# Staff Report

**To:** Salt Lake City Planning Commission  
**From:** Sara Javoronok, AICP, [sara.javoronok@slcgov.com](mailto:sara.javoronok@slcgov.com), 801-535-7625  
**Date:** July 26, 2023  
**Re:** PLNPCM2023-00354 – 9<sup>th</sup> East Mixed Use and Multi-family

## Design Review

**PROPERTY ADDRESSES:** 402 South 900 East and 410 South 900 East

**NORTH ELEVATION**

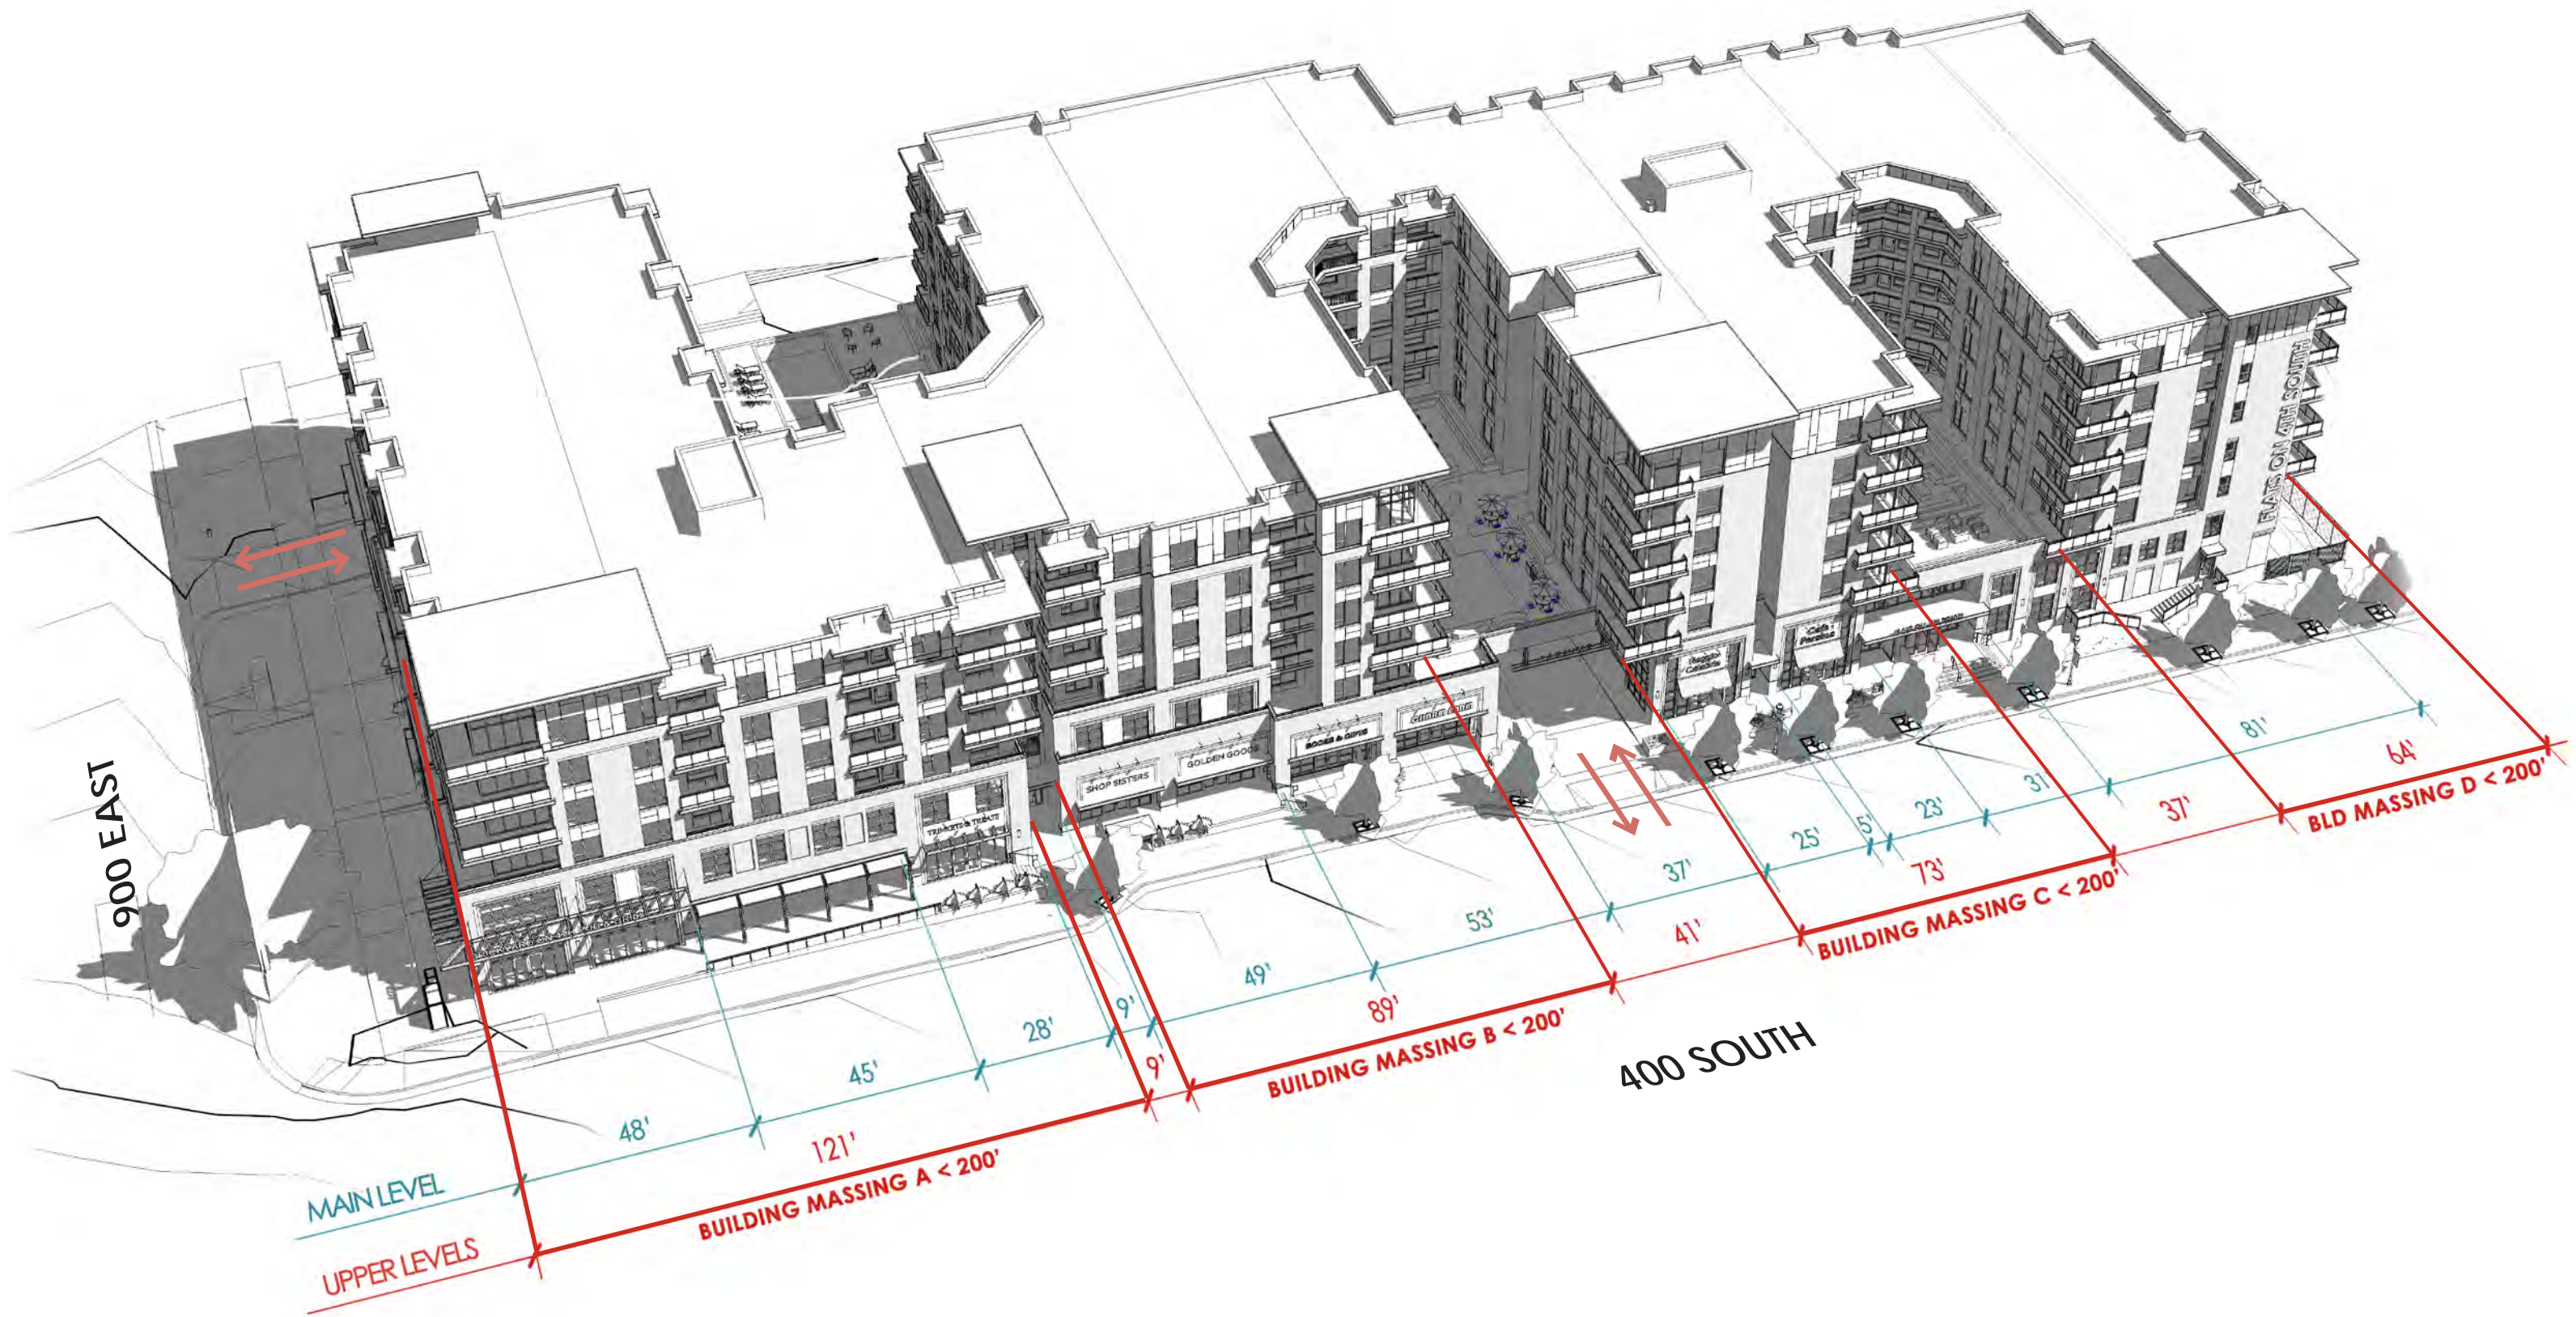
As identified above, the north façade is 434 feet long. The façade has several breaks in it that are identified in the graphic above from the applicant’s initial submittal. The revised submittal maintains the building mass widths and increases the setback of the second-floor amenity area between Building Massing B and C by 10 feet to 23 feet from the front of the building and 33 feet from the property line. From the corner of the building at 900 East and 400 South, there is a change in the building plane at 121 feet. At this location there is a building entry that is further recessed from the building plane. The next massing section of the building extends 89 feet to the 400 South entry for the parking. This entry is recessed 23 feet from the front of Building Massing C. Above the first floor it is recessed 80 feet with an amenity area occupying much of the second floor. The third building mass extends 73 feet before another break in the building plane and another amenity area that is recessed 75 feet above the mezzanine level. The final building mass fronting the street extends 64 feet. Residential units occupy floors 2-6 and many units have balconies or outdoor space fronting the amenity areas and these provide additional variation in the building plane and visual interest.

The maximum permitted building façade length is 200 feet in the TSA zoning districts. At 434 feet in length, the 400 South elevation of the proposed building exceeds this maximum by slightly more than twice what is allowed. The purpose of the maximum building façade length is to break up large expanses of building and to create spaces which are more human in scale and comfortable to the pedestrian. The proposed development seeks to accomplish this with the active uses on the ground floor, the several changes in building plane across the frontage, and the deeply recessed areas above the first floor where amenity areas are located.

1. The gate to the canal from 400 South and the fencing along the western property line shall be powder coated metal.
2. Materials not classified as durable, including metal, are subject to Planning Director determination of durable.
3. TSA Development Score approval is required prior to building permit approval.
4. Final approval of the details for signage, lighting, and landscaping are delegated to Planning staff.
5. Approval is for the specific items discussed and identified in the staff report. All other applicable zoning regulations and requirements from other city departments still apply.
6. The involved lots shall be consolidated through the Lot Consolidation process as per Chapter 20.32 of the Subdivisions and Condominiums ordinance.

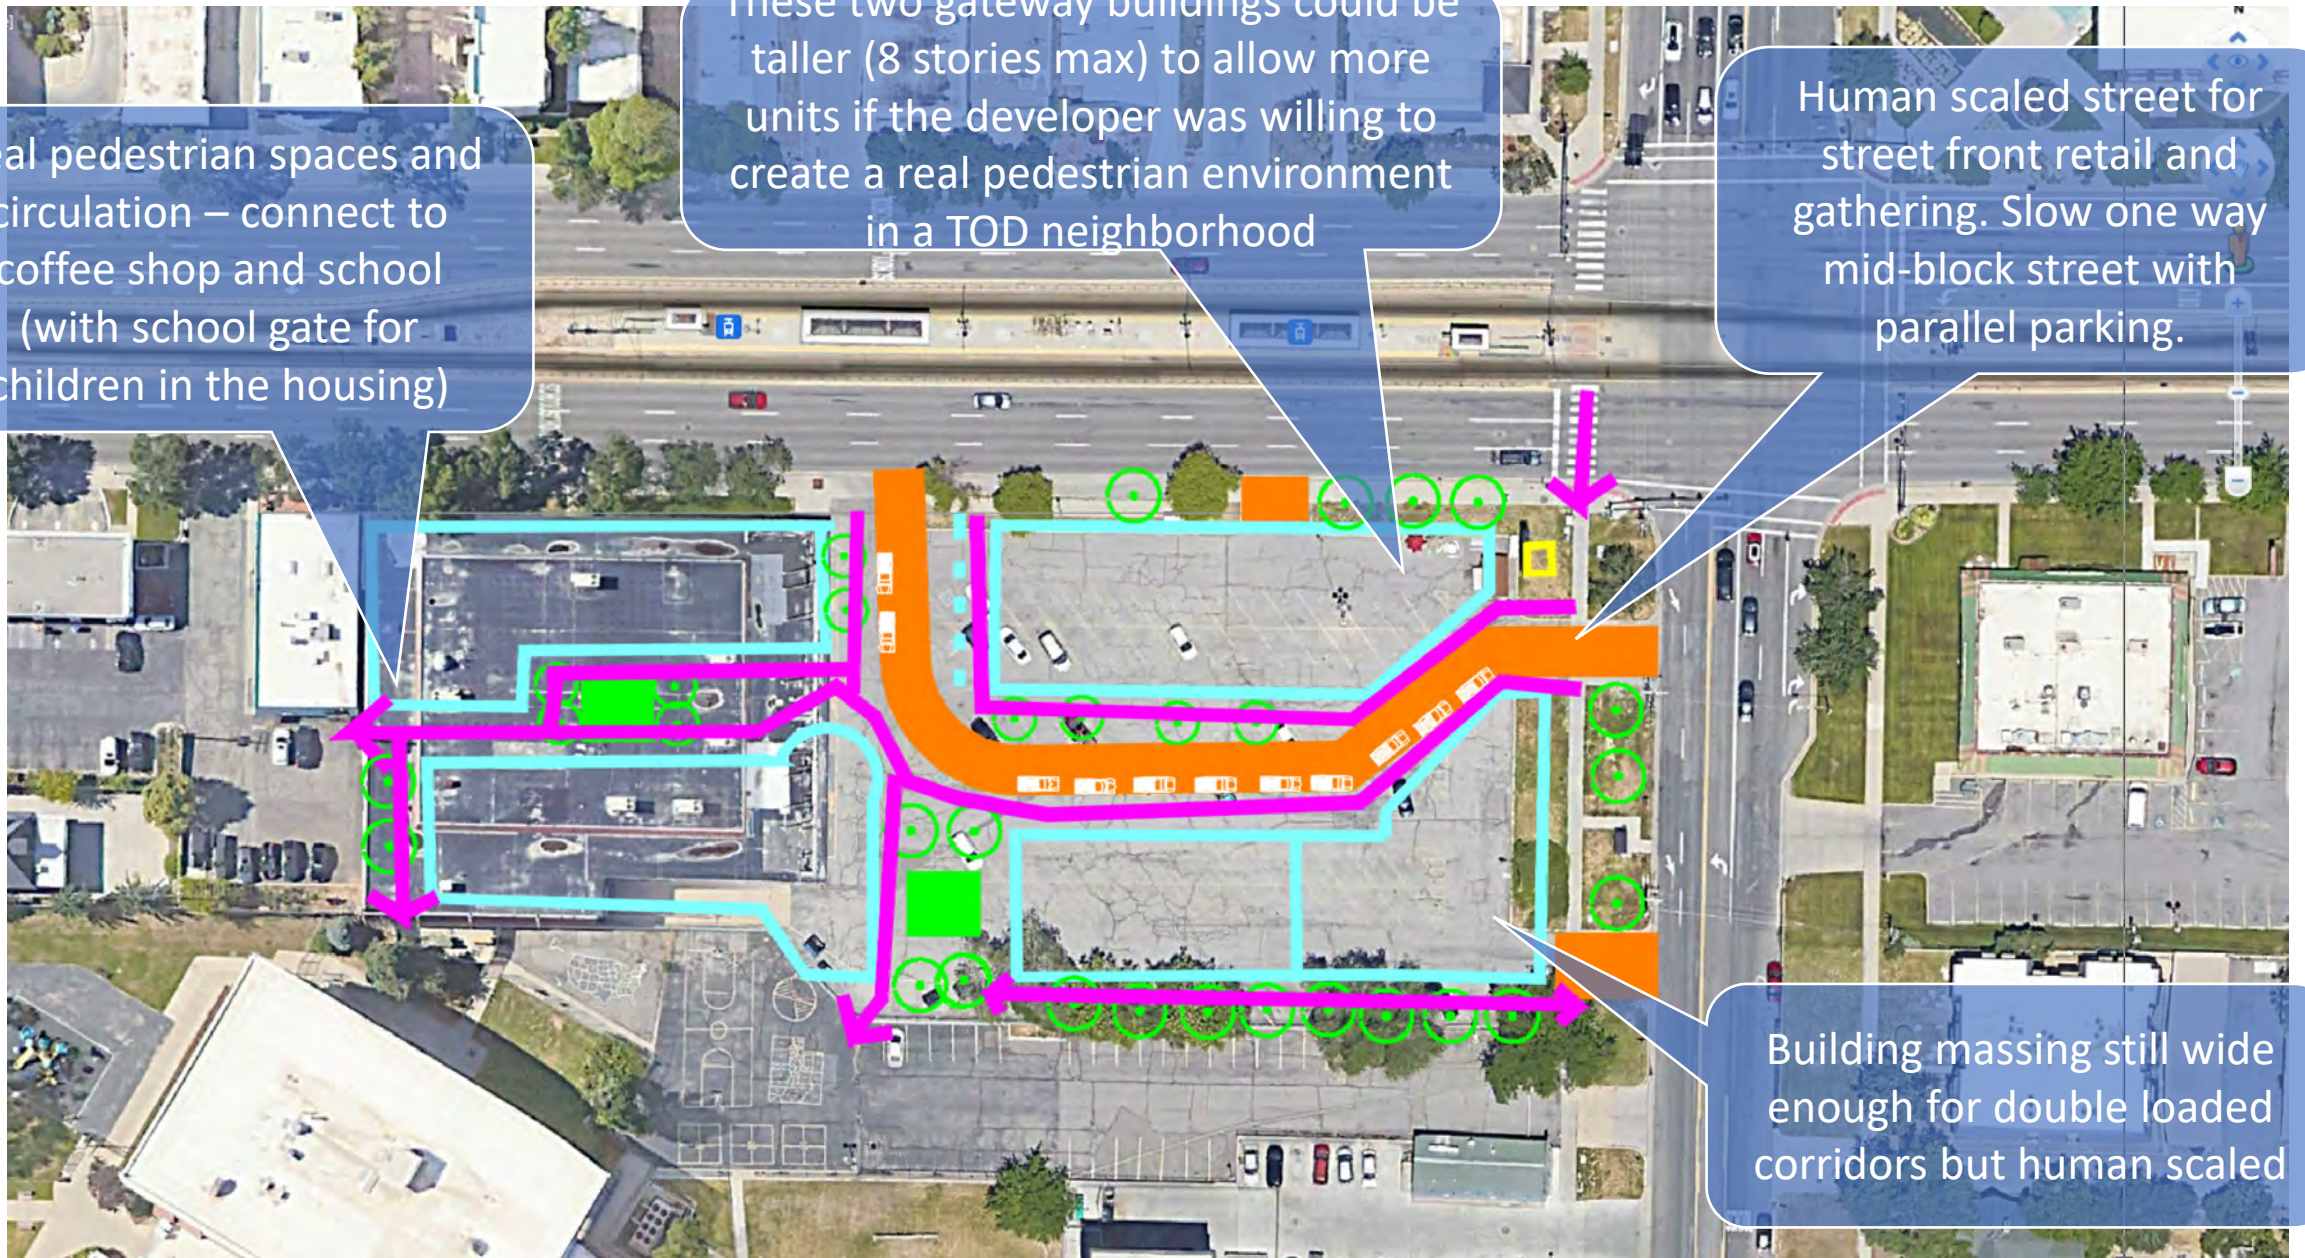
Real pedestrian spaces and circulation – connect to coffee shop and school (with school gate for children in the housing)
